Re: Sydney Adventist Hospital, Wahroonga (MP10_0070 MOD 5) Temporary Car Park

We write in response to your letter dated 6th June 2013 requesting additional information regarding the aforementioned project modification submission.

ATTACHMENT A – SIDRA Analysis Report, TTW, 18th July 2013

ATTACHMENT D – SAH Stage 1 Redevelopment Staging Plan, MBMO, 18th July 2013

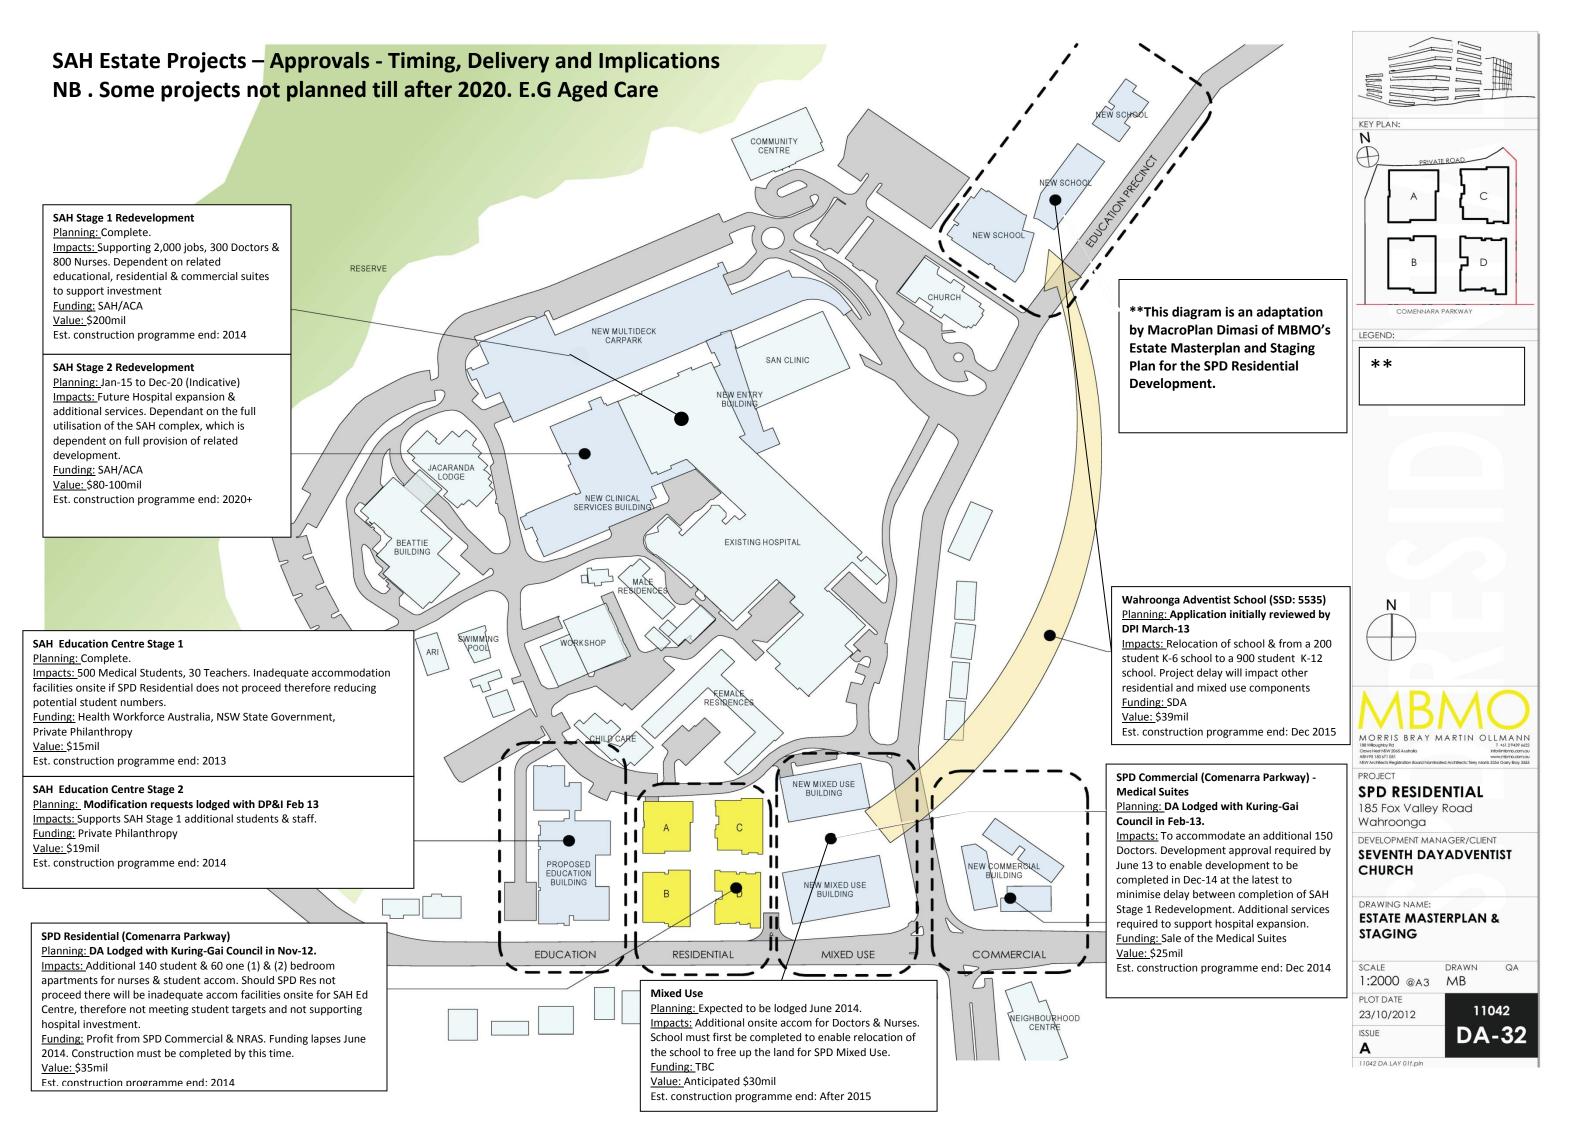
'Confirmation that the temporary car park will only be used for parking by construction workers and provision of access control details demonstrating how the general public will be restricted from accessing the car park.'

Buildcorp have implemented tool box talks and induction packages for contractors to promote the free off-street parking within the temporary car park, now known as the Contractor Car Park. Below is a sample of the map provided to contractors during induction.

Sydney Adventist Hospital can confirm that the temporary car park is and will be used for all day parking by Contractors only for the duration of the SAH works.

Currently the Wahroonga School kiss and drop is accessed through the temporary construction car park and parents are given 15 minutes free parking for this purpose only. Due to safety and other restrictions, accessing the School off Fox Valley Road directly is not possible, therefore this kiss and drop arrangement is likely to remain in place for the duration of the Hospital works.

To ensure parents and public are discouraged from parking or spending longer than 15 minutes within the car park, 'Contractor Only' signage is in place. In addition SAH have imposed a \$50 per hour parking rate for non-contractors.

ATTACHMENT C – Estate Works Programme Approvals Status and Estimated Delivery

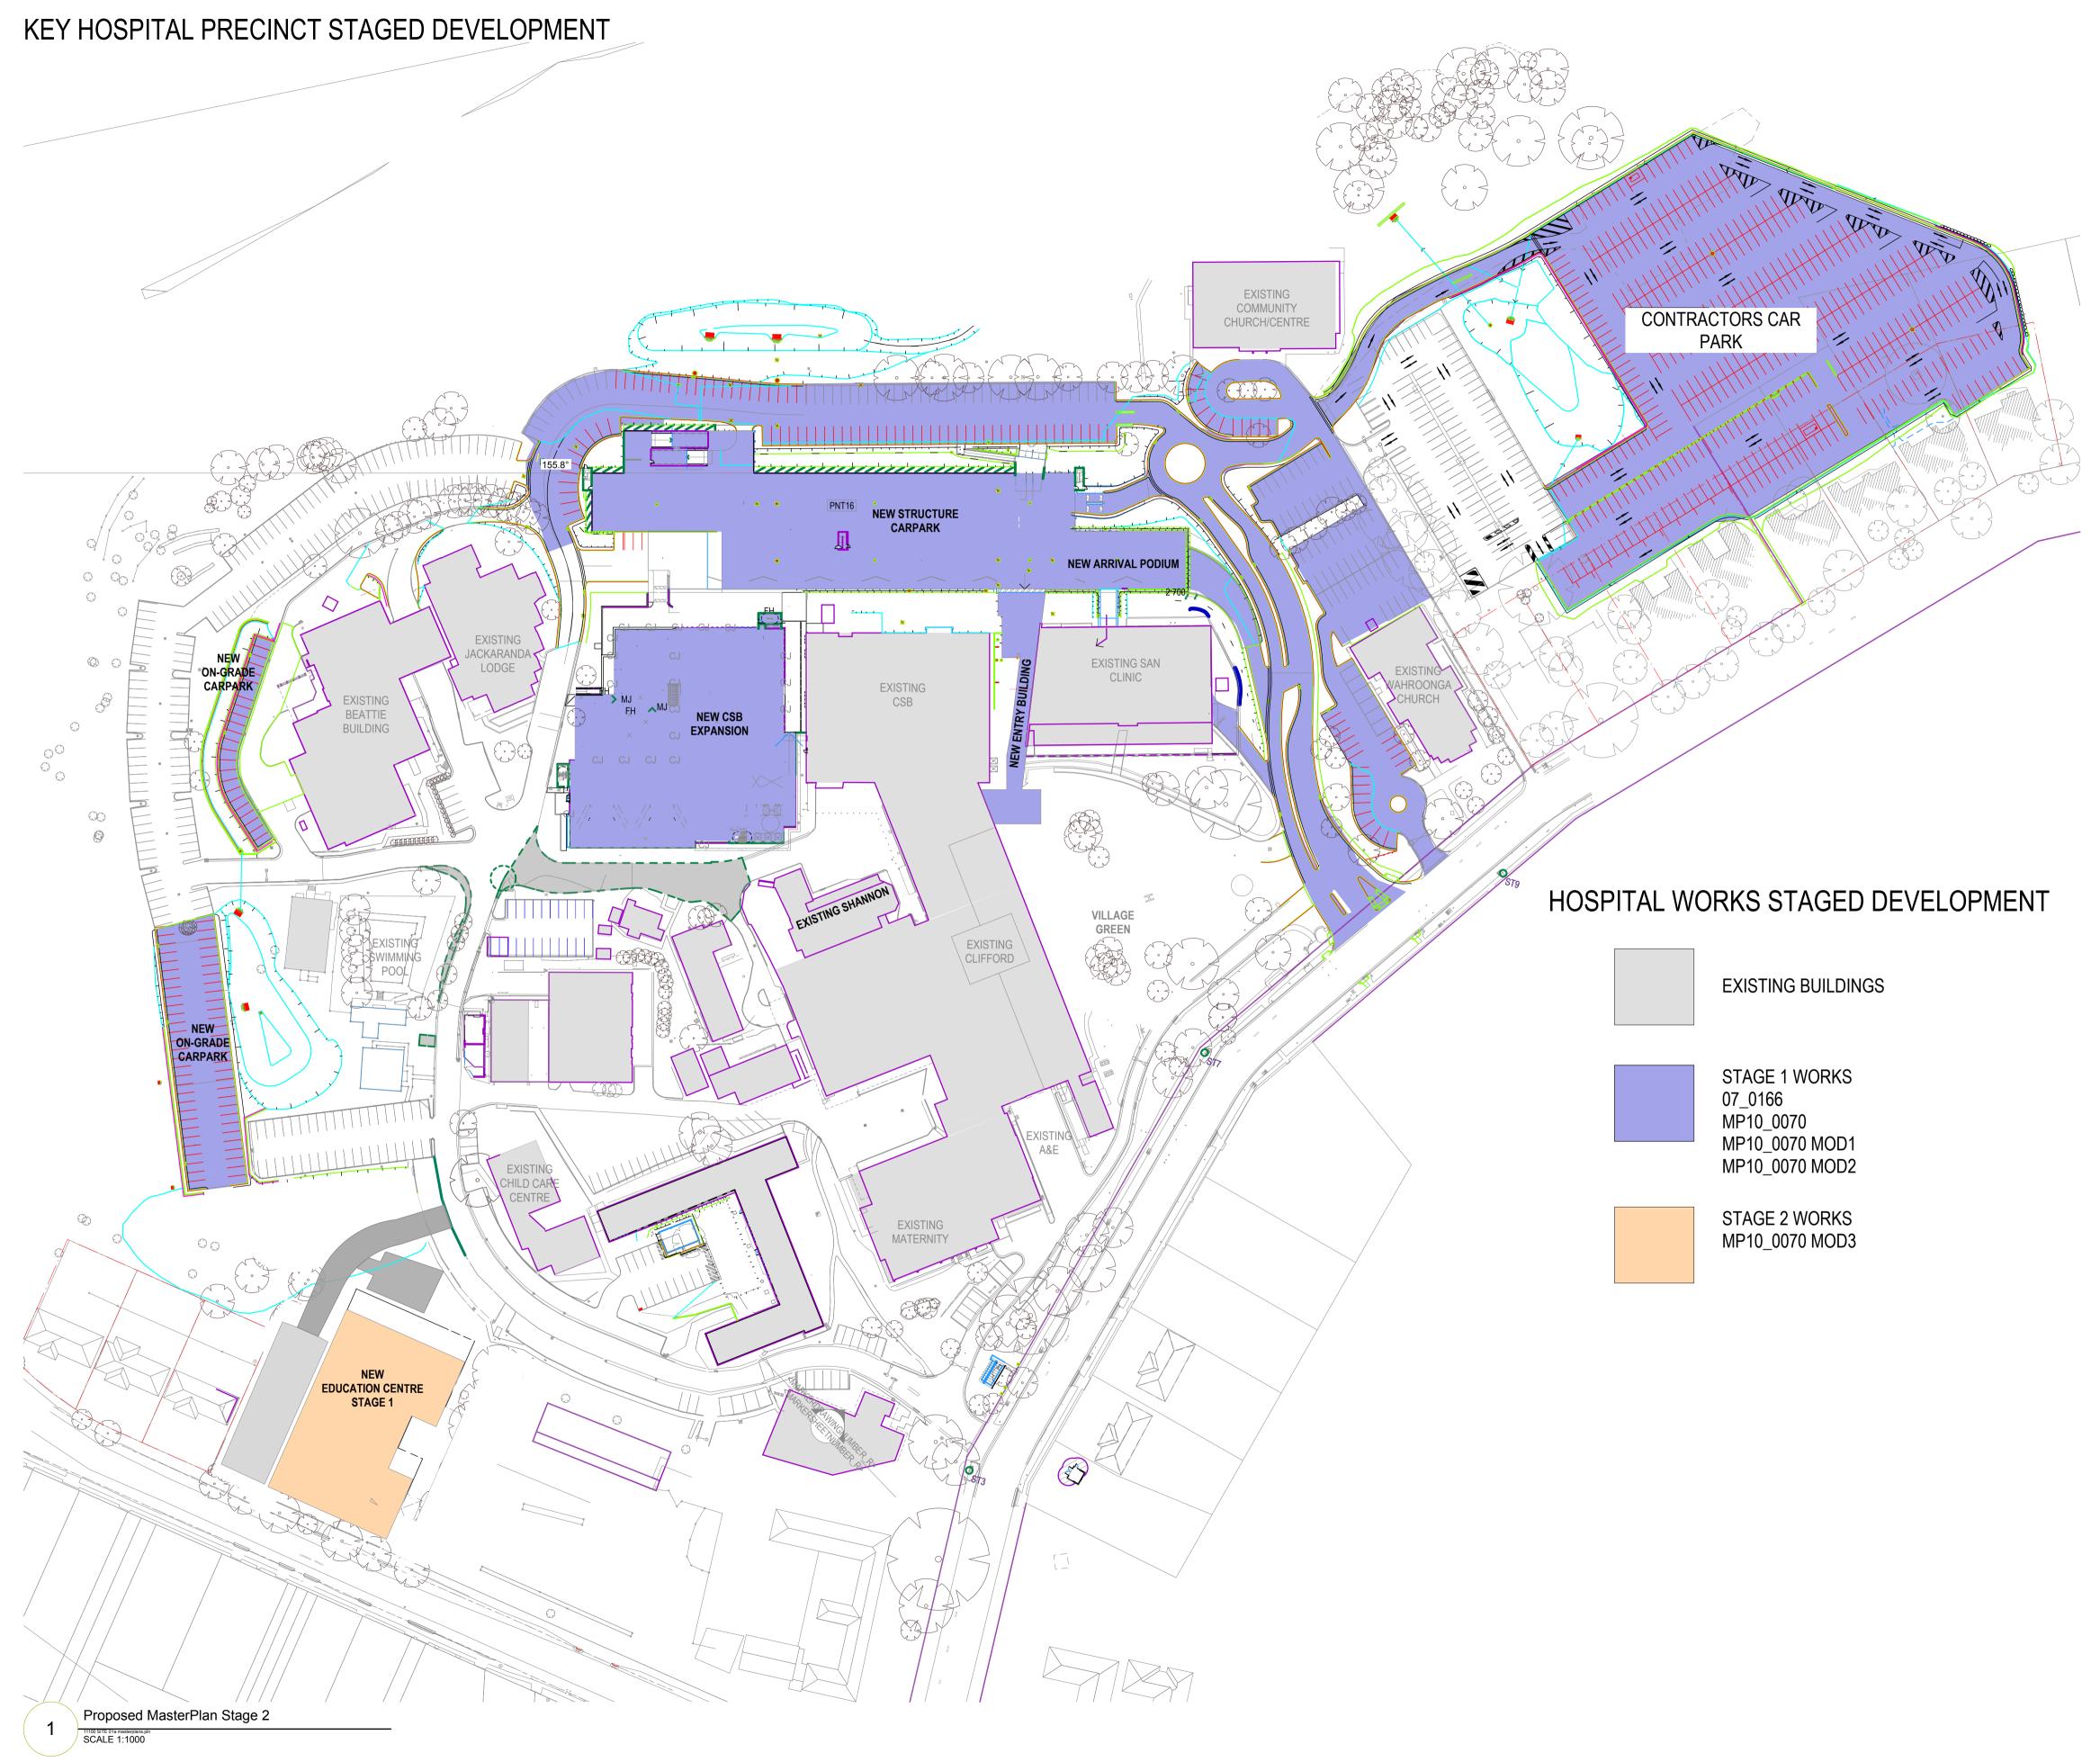
| No. | Description of Evidence | Action |
|-----|---|--|
| 4 | It is acknowledged that the modification request seeks retention of the temporary carpark throughout the redevelopment of SAH. However, the department requests further details relating to the expected duration of the carpark's retention and the consequential impacts that future developments, approved in concept under the Wahroonga Estate Concept Plan (ie. Wahroonga Adventist School), will have on the function and layout. | A programme of status – timing approvals has been provided for the Estate, <i>refer Attachment C.</i> |
